UN/SCETDG/34/INF.34/Add.1

HSL Flash Composition Test – new drawings and removal of square brackets.

Addendum to INF.34

Appendix X

[Figure X.X.8 Support Stand](#)

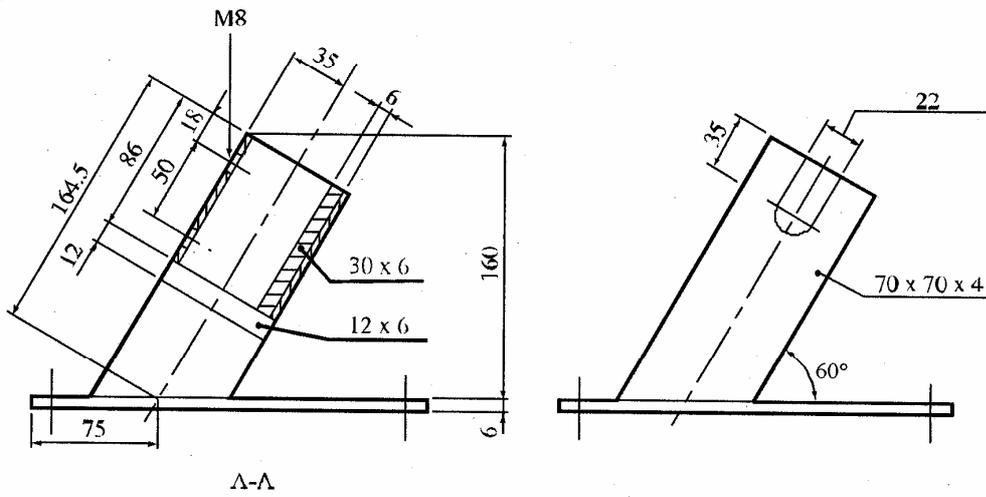
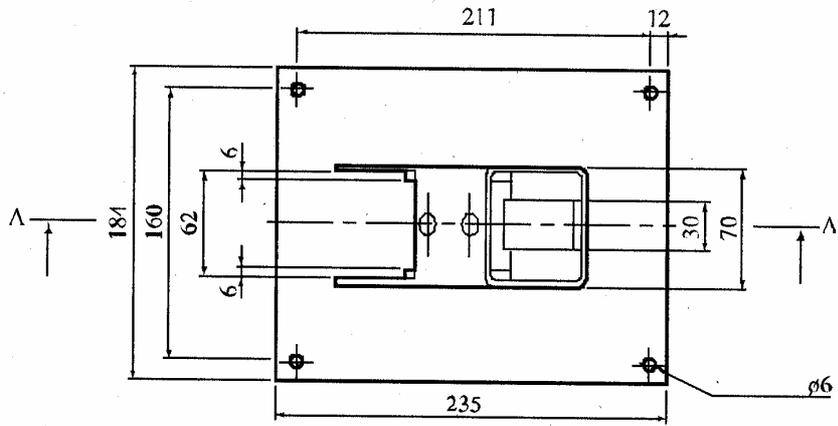
X.2.3 A support stand (X.X.8) holds the assembly in the correct attitude during use. This comprises a mild steel base plate measuring 235 mm × 184 mm × 6 mm and a 185 mm length of square hollow section (S.H.S.) 70 × 70 × 4 mm. A section is cut from each of two opposite sides at one end of the length of S.H.S. so that a structure having two flat sided legs surmounted by an 86 mm length of intact box section results. The ends of these flat sides are cut to an angle of 60° to the horizontal and welded to the base plate.

X.2.4 A slot measuring 22 mm wide × 46 mm deep is machined in one side of the upper end of the base section such that when the pressure vessel assembly is lowered, firing plug end first, into the box section support, the side-arm is accommodated in this slot. A packing piece of steel 30 mm wide and 6 mm thick is welded to the lower internal face of the box section to act as a spacer. Two 7 mm thumb screws, tapped into the opposite face, serve to hold the pressure vessel firmly in place. Two 12 mm wide strips of 6 mm thick steel, welded to the side pieces abutting the base of the box section, support the pressure vessel from beneath.
